**SHEARON HARRIS NUCLEAR POWER PLANT, UNITS 2 AND 3
DOCKET NOS. 52-022 AND 52-023
RESPONSE TO REQUEST FOR ADDITIONAL INFORMATION LETTER NO. 007 RELATED TO
IDENTIFICATION OF POTENTIAL HAZARDS IN SITE VICINITY**

**Shearon Harris Nuclear Power Plant Units 2 and 3
Responses to NRC Request for Additional Information Letter No. 007 Related to SRP Section
02.02.01-02.02.02 for the Combined License Application, dated August 21, 2008**

Revised FSAR Figure 2.2.2-201 (Rev 1 Draft) – Regional Airports

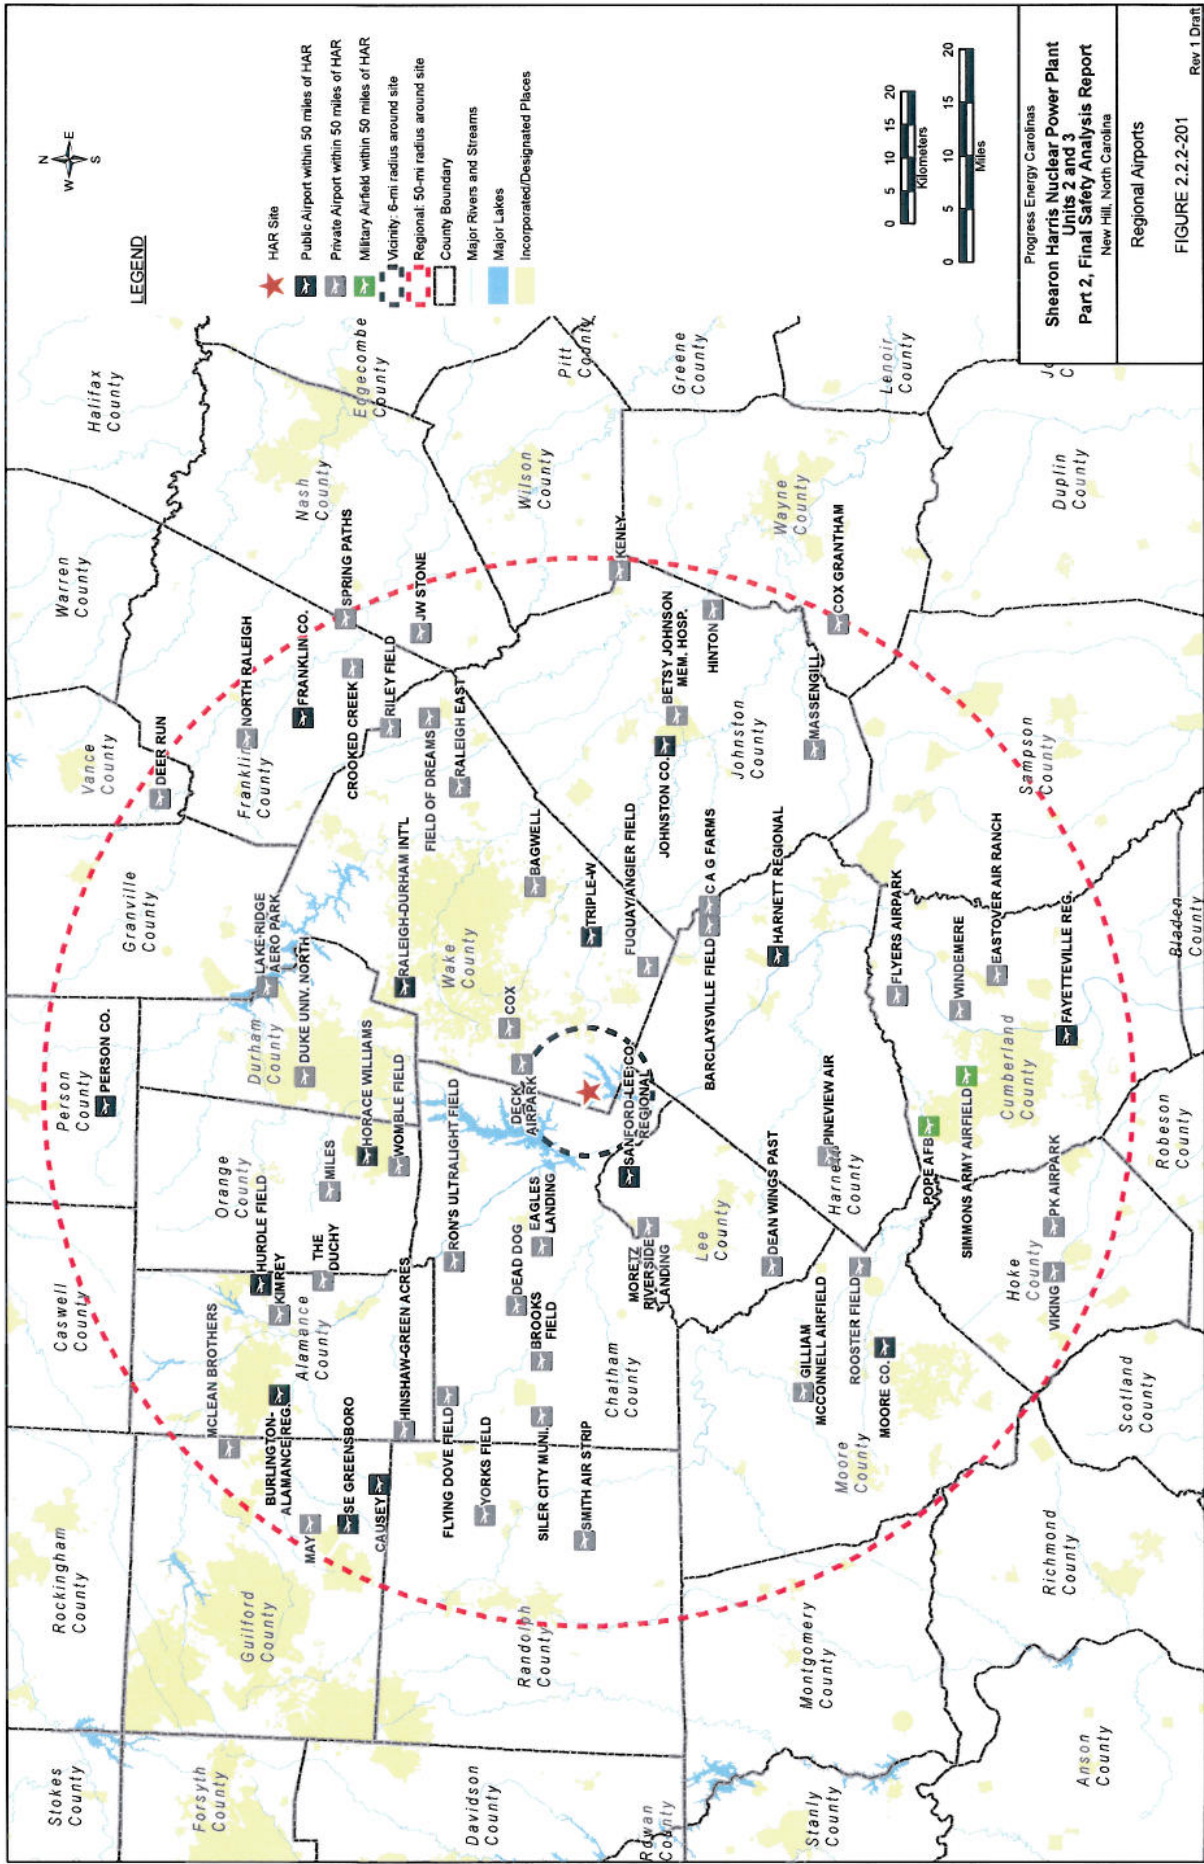
RG 1.206 provides guidance regarding the information that is needed to ensure potential hazards in the site vicinity are identified and evaluated to meet the siting criteria in 10 CFR 100.20 and 10 CFR 100.21. The FSAR Section 2.2.2.7 does not provide this information adequately to review this section. The Staff's review indicates that there are more than three airports within 20 miles and numerous airports within the region of 50 mile radius (between 20 - 50 miles) of HAR site. Please either address these in the FSAR or give rationale for exclusion.

7. Replace FSAR Figure 2.2.2-201, in its entirety, with the version listed under **Attachments/Enclosures** below. Modifications include the addition of other airports within the 50 mile region of the HAR Site.

Revised FSAR Figure 2.2.2-202 (Rev 1 Draft) – Airports and Airways in Vicinity of HAR

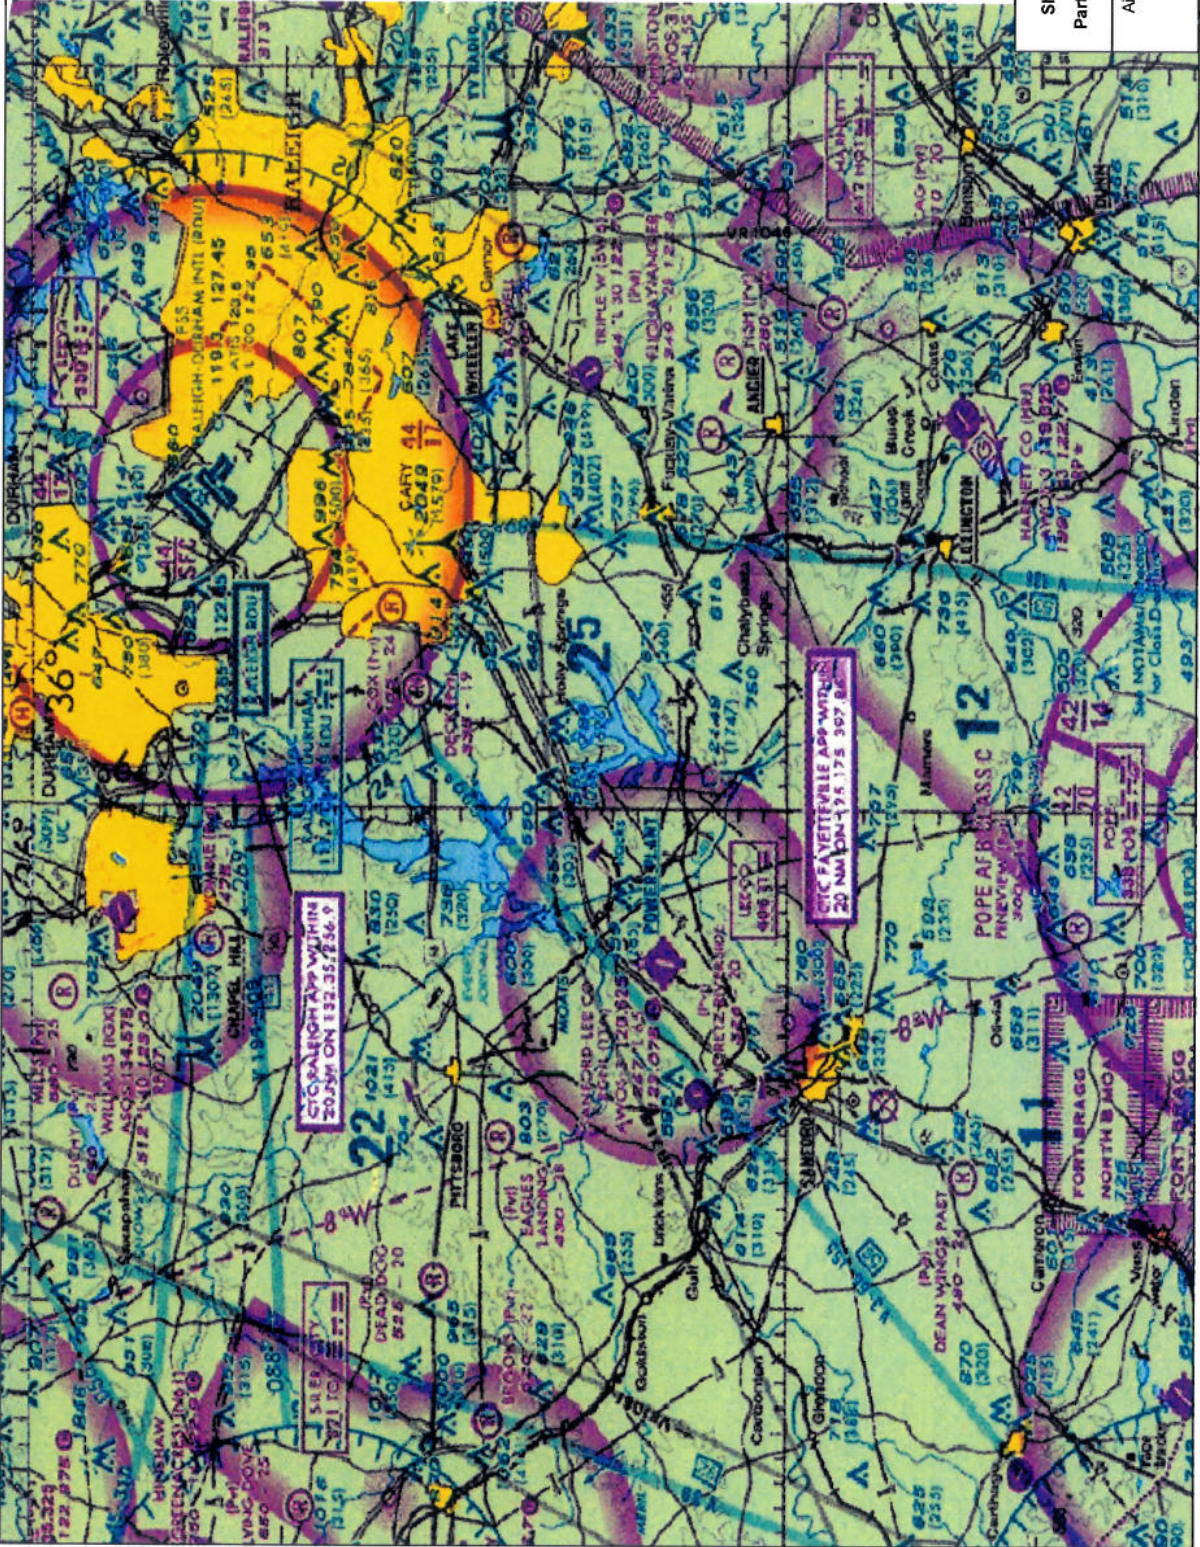
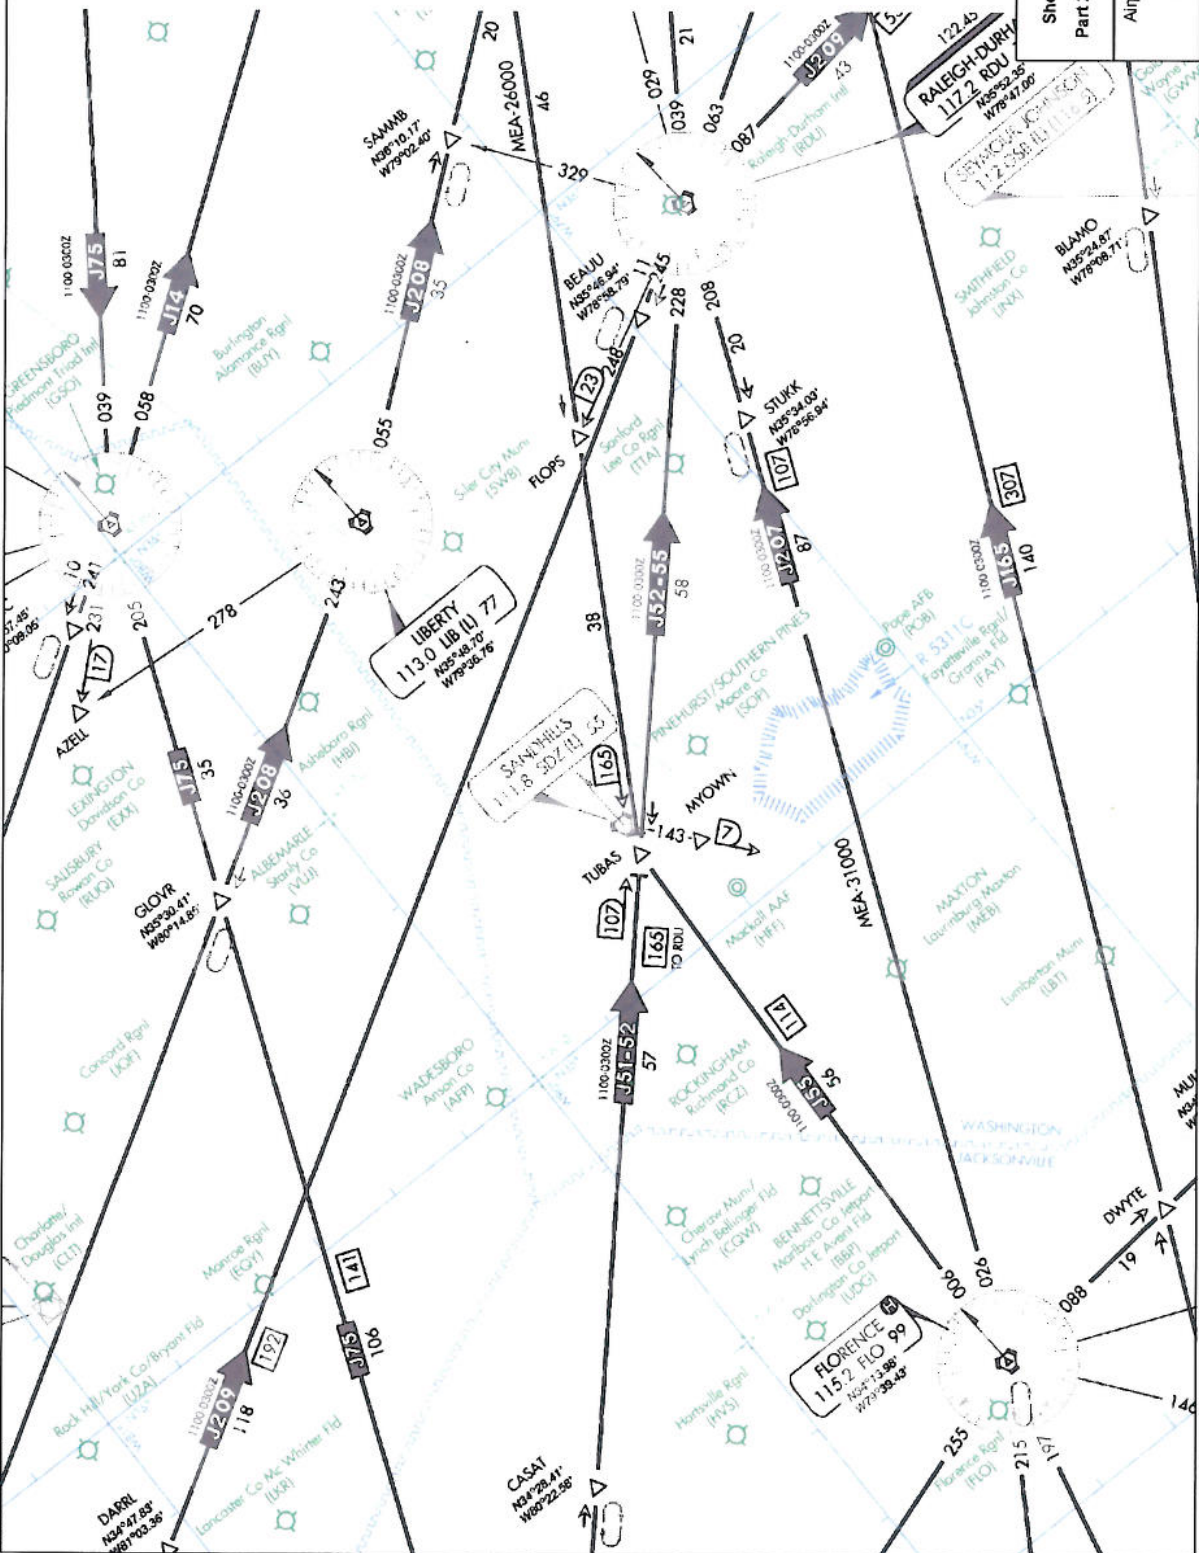
RG 1.206 provides guidance regarding the information that is needed to ensure potential hazards in the site vicinity are identified and evaluated to meet the siting criteria in 10 CFR 100.20 and 10 CFR 100.21. The FSAR Section 2.2.2.7 does not provide this information adequately to review this section. The NRC Staff's review indicates that there two Federal jet routes Airway J207 and J52- 55, whose nearest edges are well within 2 miles of HAR site. Therefore, in accordance with the acceptance criteria 3.5.1.6, the aircraft hazards associated with these jet routes should be evaluated and addressed in Section 3.5.1.6. Please evaluation, or provide justification for their exclusion.

The centerline of Airways V3-66-155, J207 and J52-55 are located 5.5, 2.6 and 3.8 miles, respectively, of the HAR site. The boundary of each these airways is 4 nautical miles from the centerline. Thus, the outer boundary of each of these airways is within 2 miles of the HAR site. Therefore, an aircraft hazards evaluation of these airways will be conducted. After the evaluation is completed, the revision to FSAR Subsection 3.5.1.6 (to be added to the FSAR in a future amendment) will be submitted to the NRC by January 30, 2009.

"The outer boundary of four airways are routed within 2 miles of the HAR site: IR718, V3-66-155, J207 and J52-55 (shown on Figure 2.2.2-202)."

2. Replace FSAR Figure 2.2.2-202, in its entirety, with the version listed under **Attachments/Enclosures** below. A second sheet has been added to Figure 2.2.2-202 that indicates the routes of Airways J207 and J52-55.
